SUBJECT: AMENDMENT NO. 224 TO FACILITY OPERATING LICENSE NO. DPR-49 -  
 DUANE ARNOLD ENERGY CENTER (TAC NO. MA1574)

AMENDMENT TO FACILITY OPERATING LICENSE

Amendment No. 224  
License No. DPR-49

SAFETY EVALUATION BY THE OFFICE OF NUCLEAR REACTOR REGULATION  
RELATED TO AMENDMENT NO. 224 TO FACILITY OPERATING LICENSE NO. DPR-49

Figure 3.4.9-1 (page 1 of 1)

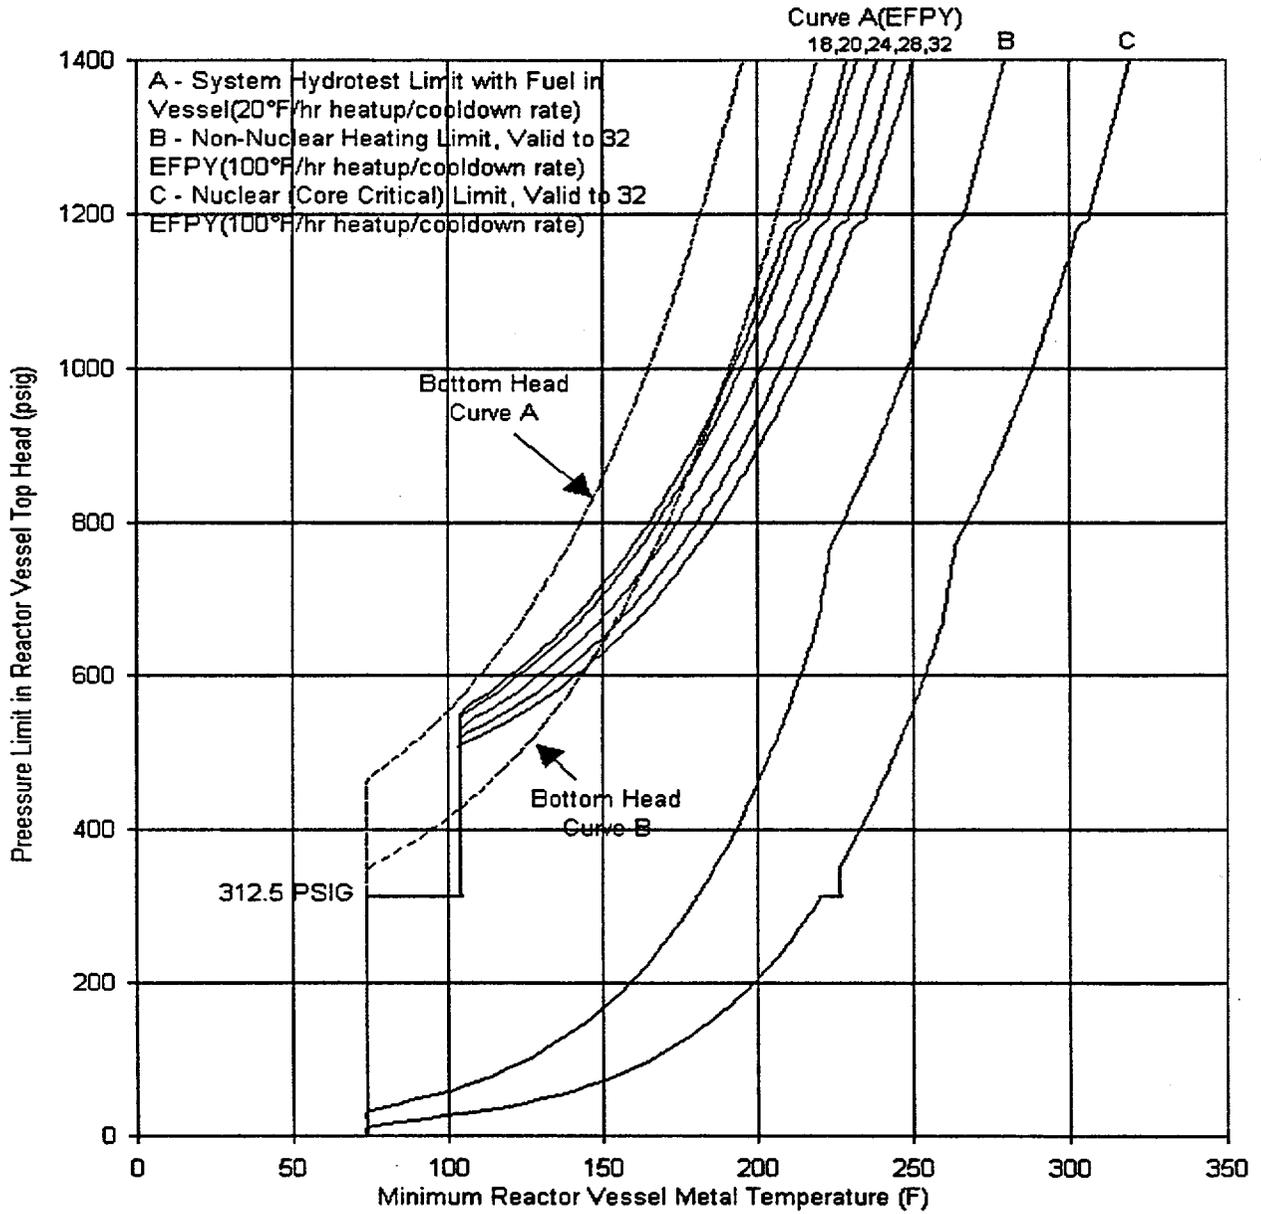
The amendment updates the existing pressure-temperature curves with new curves with values from 18 to 32 effective full power years. Applicable surveillance requirements are also revised to reflect operation with the new curves.

As stated above, the licensee submitted ART calculations and P-T limit curves valid for up to 18, 20, 24, 28, and 32 EFPY. The staff independently verified the accuracy of the licensee's ART calculations. In addition, the staff independently generated P-T curves for normal operations and hydrostatic test pressures effective to 32 EFPY. The details of this evaluation are provided below.

The staff performed an independent calculation of the ART values for the limiting material using the methodology in RG 1.99, Revision 2. Based on these calculations, the staff verified that the licensee's limiting material for the Duane Arnold reactor vessel is the shell #2 ring plate (1-21) that was fabricated using plate heat B0673-1. The staff's calculated ART values for the limiting material agreed with the licensee's calculated ART values at 32 EFPY. Substituting the ART values for the Duane Arnold limiting plate into the equations in SRP 5.3.2, the staff verified that the proposed P-T limits satisfy the requirements in Paragraph IV.A.2 of Appendix G of 10 CFR Part 50. The staff independently generated P-T curves for normal operations and hydrostatic test pressures effective to 32 EFPY. In comparing the staff's generated curves to the licensee's generated curves, the staff determined that the P-T curves for Duane Arnold meet the requirements of Appendix G of Section XI of the ASME Code. It should be noted that the P-T limit curves valid for up to 18, 20, 24, and 28 EFPY were generated by the licensee using the same methodology as the 32 EFPY P-T limit curves; therefore, the staff also determined that these curves meet the requirements of Appendix G of Section XI of the ASME Code.

Pressure Versus Minimum Temperature Valid to Thirty-two Full Power Years, per Appendix G of 10CFR50

The staff concludes that the proposed P-T limits for the reactor coolant system for heatup, cooldown, leak test, and criticality satisfy the requirements in Appendix G to Section XI of the ASME Code and Appendix G of 10 CFR Part 50 for 32 EFPY. The proposed P-T limits also satisfy Generic Letter 88-11 because the method in RG 1.99, Rev. 2 was used to calculate the ART. Hence, the proposed P-T limits may be incorporated into the Duane Arnold technical specifications.
